APPENDIX V
DETAILS OF TRANSPORTATION ACCIDENTS

DETAILS OF TRANSPORTATION ACCIDENTS

Figure V-1 Event tree for highway accidents (from Mills, et al, 2006)

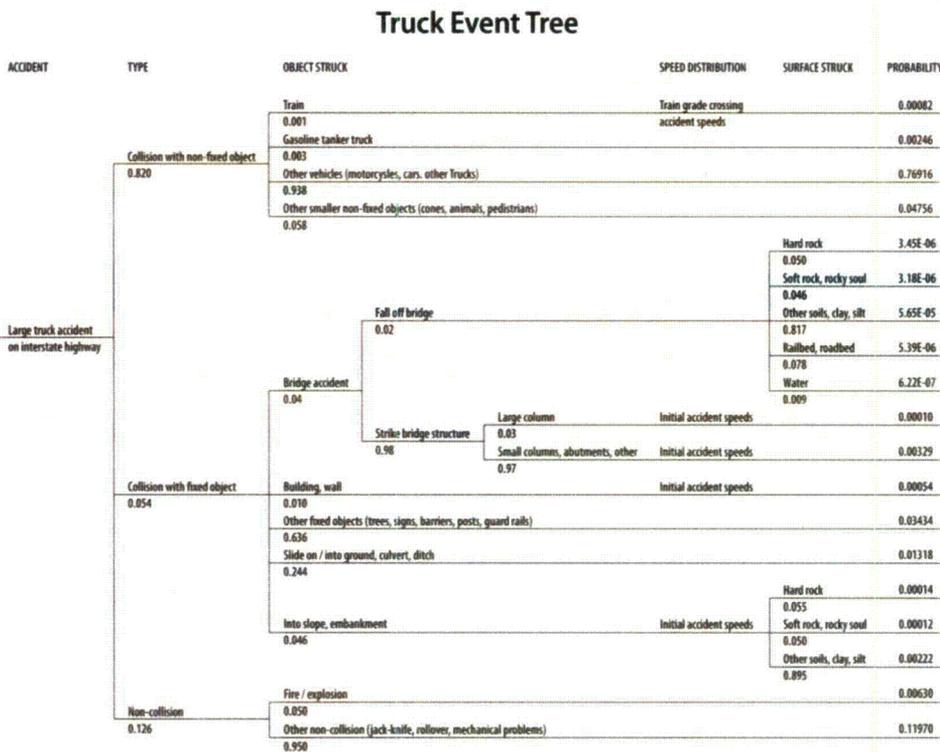
Comment [h6]: According to the Truck event tree below, the P(bridgeaccident) value should be 0.04, not 0.064.

Comment [h7]: Only 5% of the truck accidents were with fixed objects? This seems awfully low.

Figure V-2 . Rail accident event tree (after Volpe, 2006)

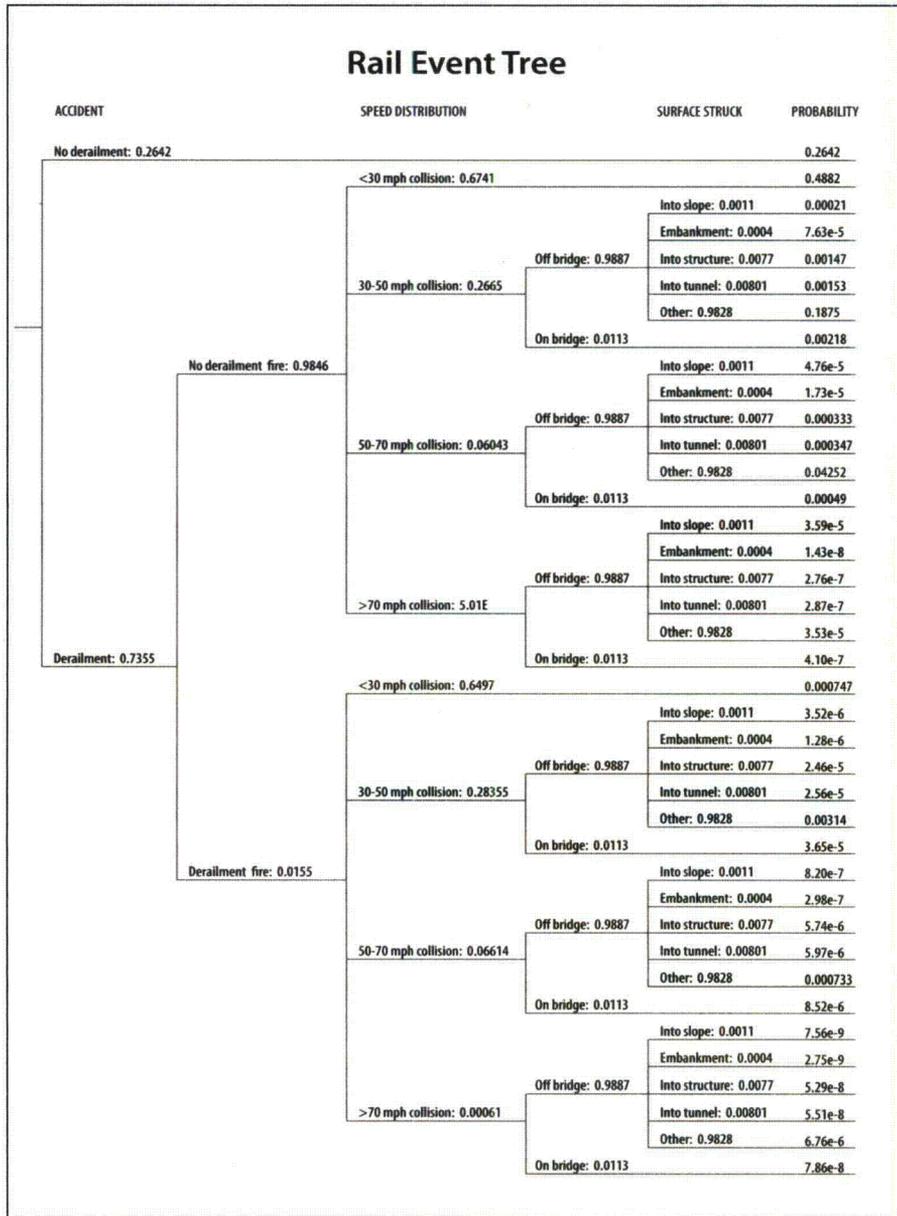
Comment [MF8]: The mixing of units will make this difficult for end users. Consider Table V-2 and Fig. V-2. Fig. V-2 is in mph but Table V-2, which uses Fig. V-2 for its conditional probabilities is in kph. This isn't the only place however. The fire event tree (Fig. V-4) uses feet.

Comment [h9]: In the event tree how does a "derailment" lead to a "No derailment fire". Aren't these logically inconsistent? Should that be *Derailment no fire*?

Figure V-3. The RADTRAN Loss-of-Shielding 2-D Model (O'Donnell, et al, 2005)

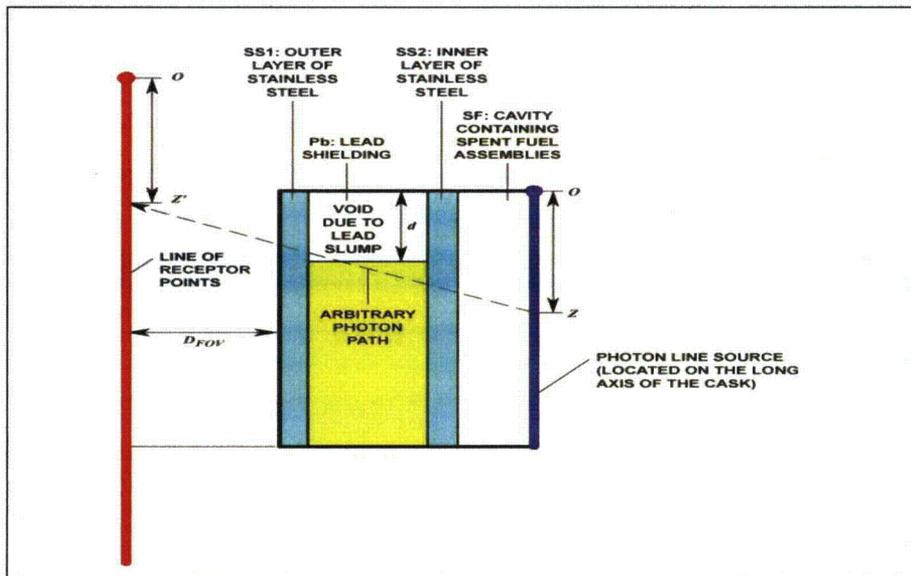
Comment [h11]: On the one hand you mention that the model is symmetric, and on the other you identify the cask as having different gaps on opposite sides. This leads to the question, symmetric with respect to what – obviously not in the finest details that would include things like gaps etc. Some additional explanation would be useful.

Comment [s12]: The text and corresponding figure V-3 are stated as the model for the loss-of-shielding treatment in RADTRAN. More detail is needed, this is a very difficult shielding problem and a brief description of how the model was solved is needed to give the reader confidence in the results.

Figure V-4. Radiation dose for one hour to the maximally exposed individual (MEI) from loss of lead gamma shielding at distances from one to five meters from the cask carrying spent fuel.

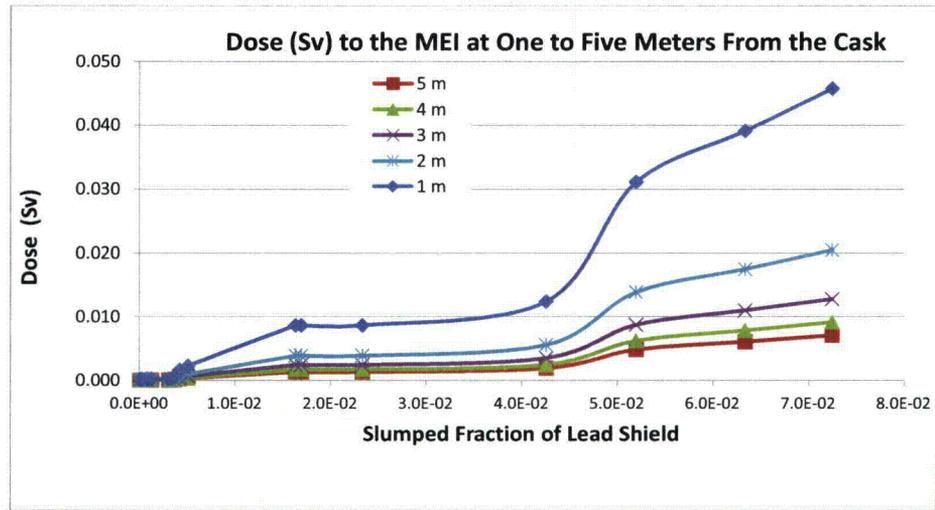
Comment [h16]: As noted in comments on Chapter 5, Run example case for 1m to test results that seem slightly unusual compared with the other cases.

Comment [s17]: The results shown in Figure V-4 also do not give the reader confidence in the results in that the "bumps" in the curves for 1 m don't really make physical sense.

Figure V-5. Radiation dose to the maximally exposed individual from loss of lead gamma shielding at distances from 20 to 100 meters from the cask carrying spent fuel. The vertical axis is logarithmic, so that all of the doses can be shown on the same graph.

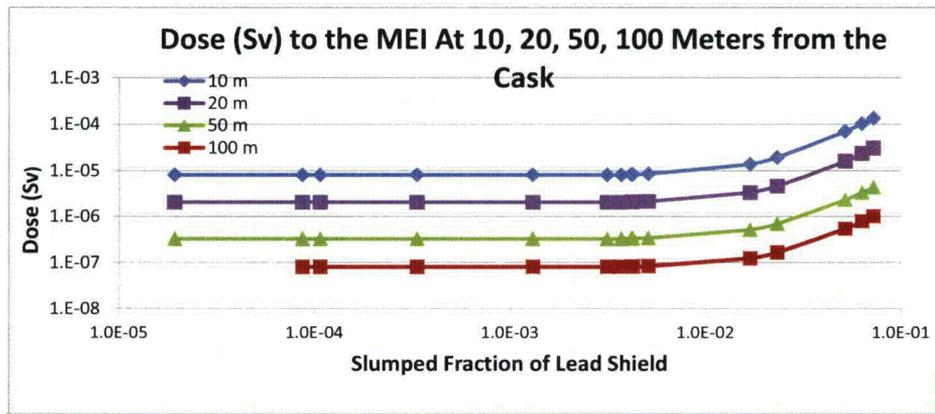
Comment [XXX18]: Data missing from 100 m line.

Comment [h19]: Reference for the 10 meters. Where does the 1.33 mSv value come from - estimated from Figure V-5?

Figure V-4. Event tree branch for a rail fire accident (from Volpe, 2006, Figure 16)

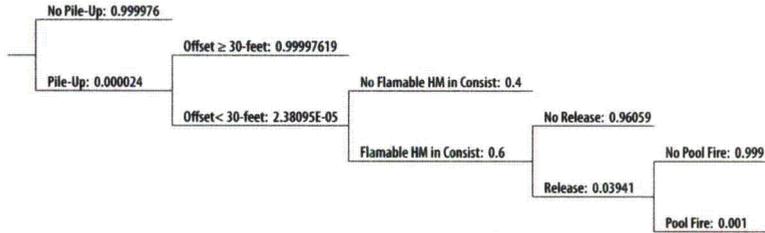
Comment [MF36]: Should this be Figure V-4?
